RE: Response to Adequacy Review No. 1
Technical Revision No. 4 – Hukill Gulch Millsite
Task 1: Logistical Assessment and Removal Action Plan and Specifications

TECHNICAL REVISION 4

(As Modified 02/01/2017 to Address Adequacy Response No. 1)

Figure 3 - Site Detail
Clear Creek County, CO
Project No. 107732000

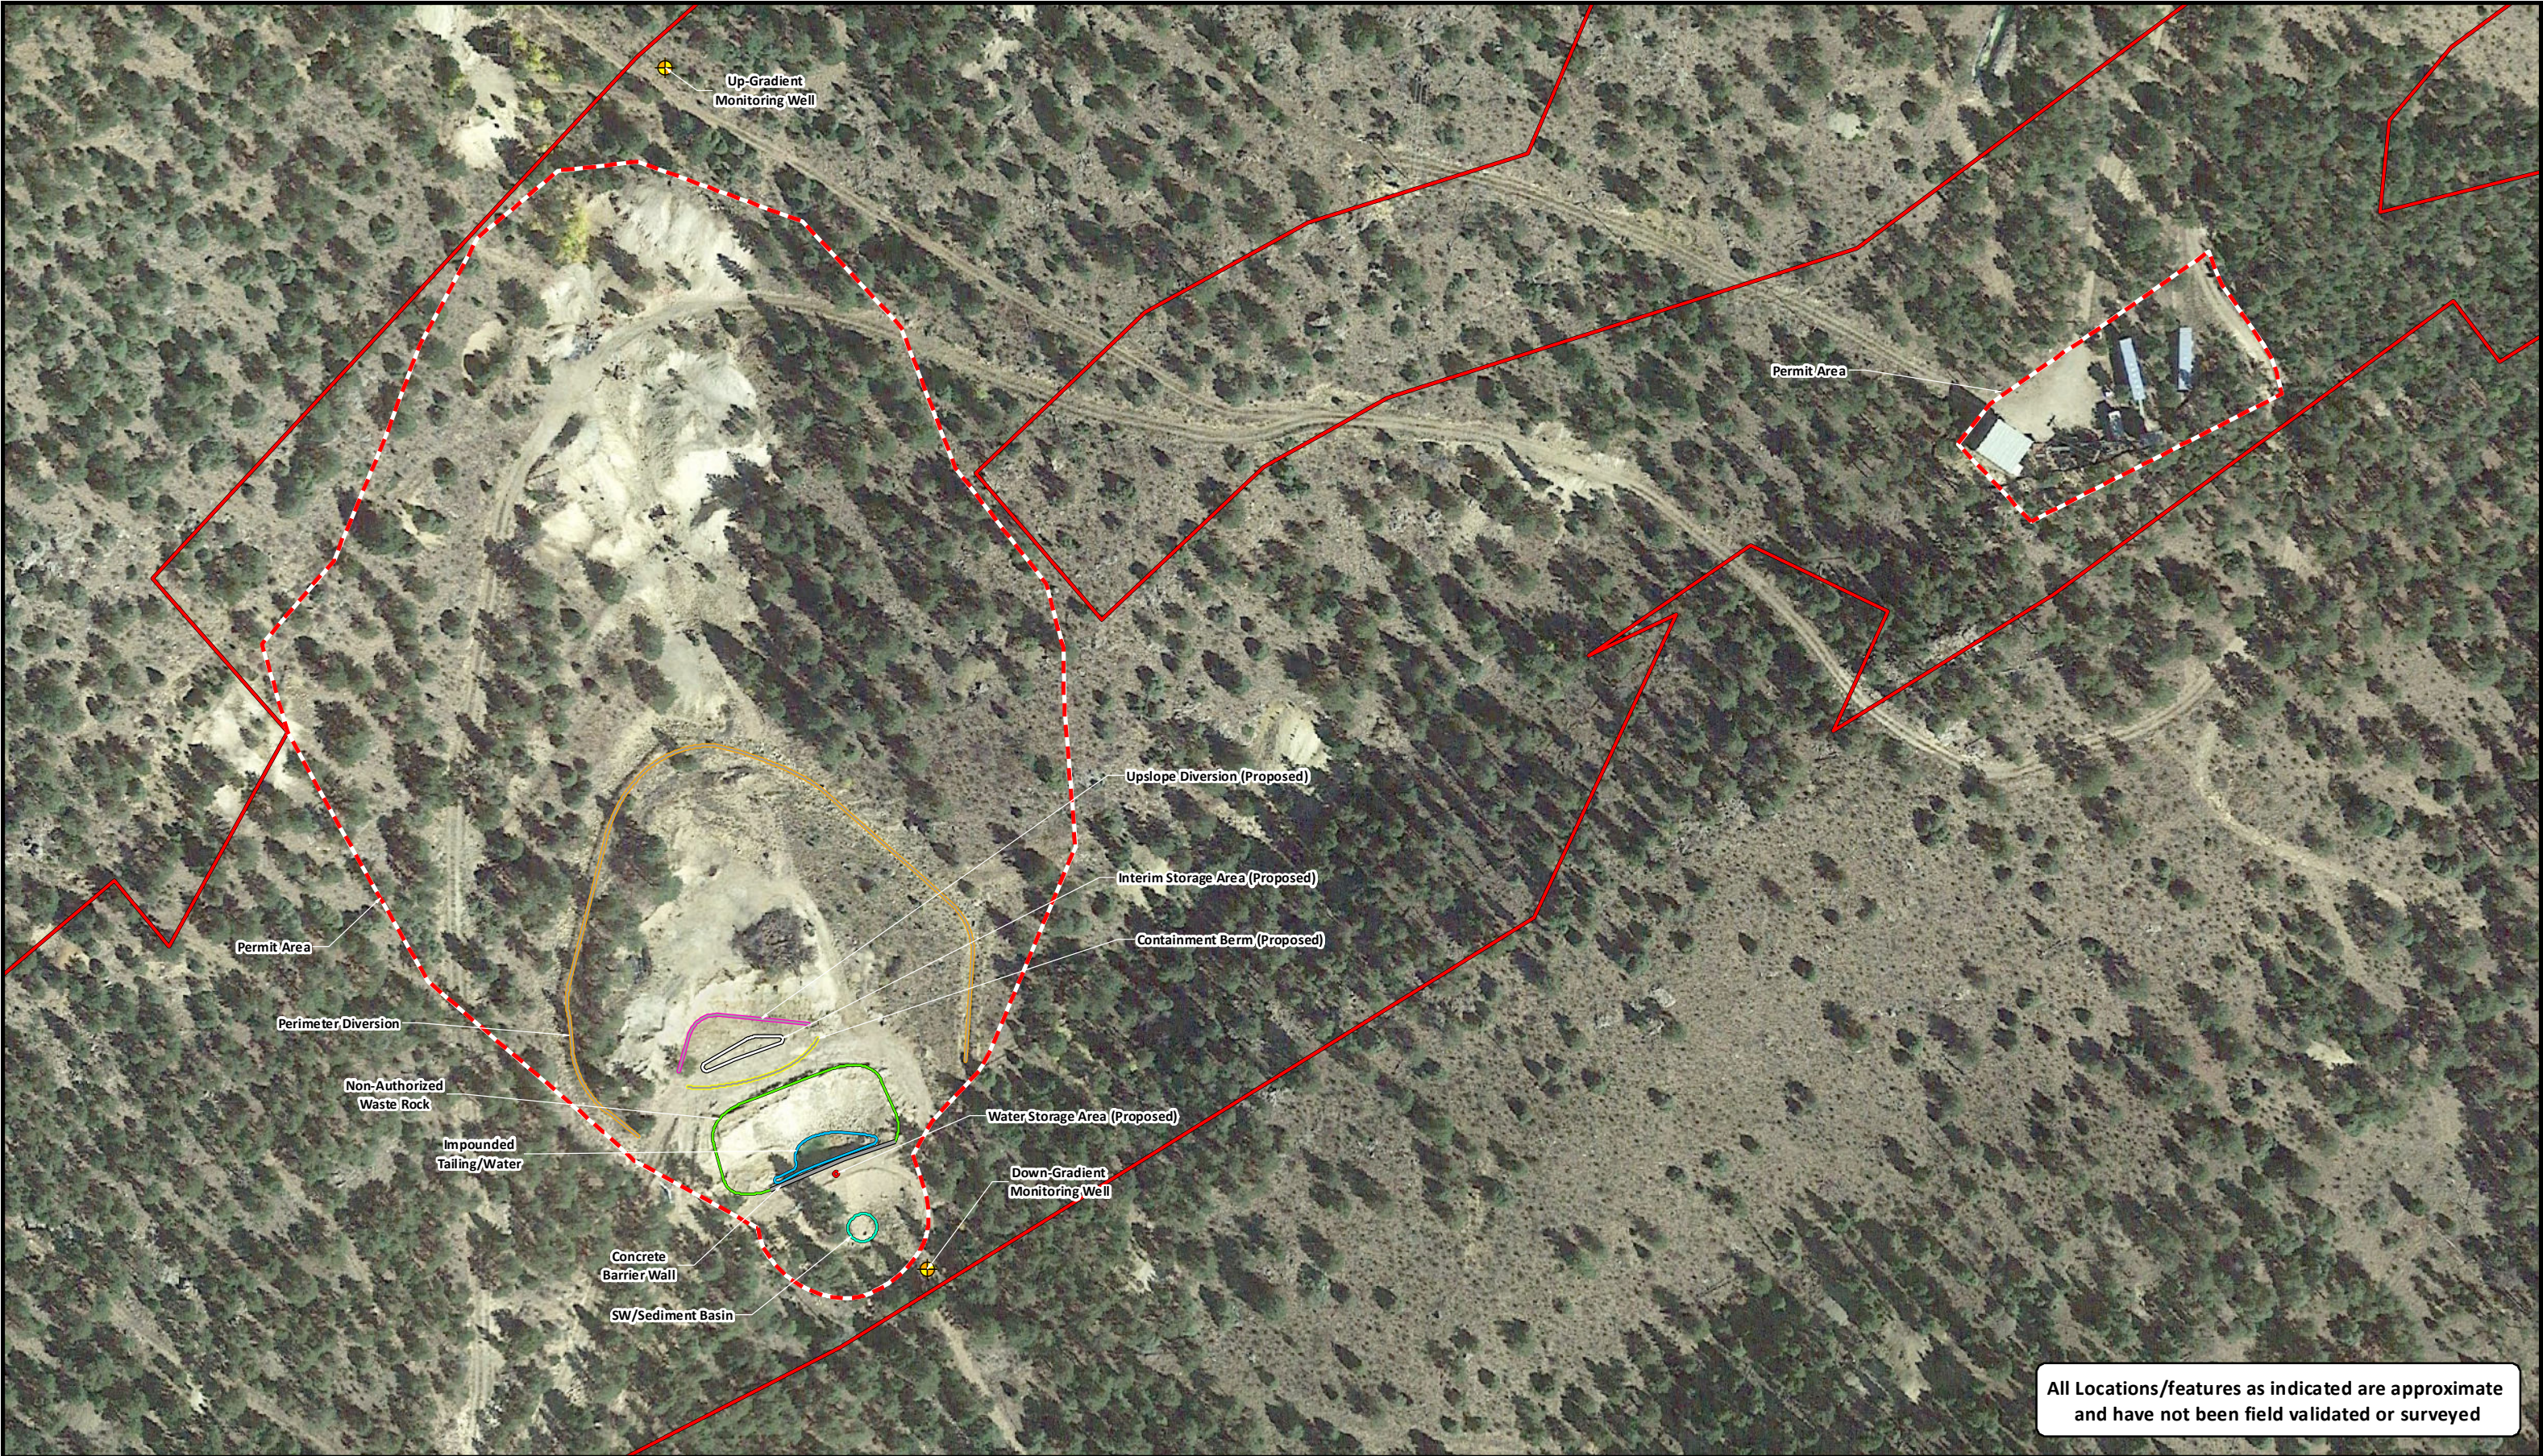
Item 1: Please provide a map which depicts the locations of the following: (a) the staging and stockpile area for the non-authorized waste rock; (b) the stockpile area for the man-made materials and debris; and, (c) the temporary storage area for the residual liquids.

It is **Figure 3: Site Detail** that identifies each of the respective areas (or provides for a specific point of reference) as requested by the Division. The intended stockpile area for the man-made materials and debris is not specifically identified in Figure 3; however, it will be located within the overall stockpile area at a location to be determined, dependent on volume (anticipated to be minimal) and in consideration of potential salvage/disposal opportunities. *[Note: All other Attachments remain in their original sequence, but Attachment numbers have been advanced to reflect the insertion of the new Attachment I]*
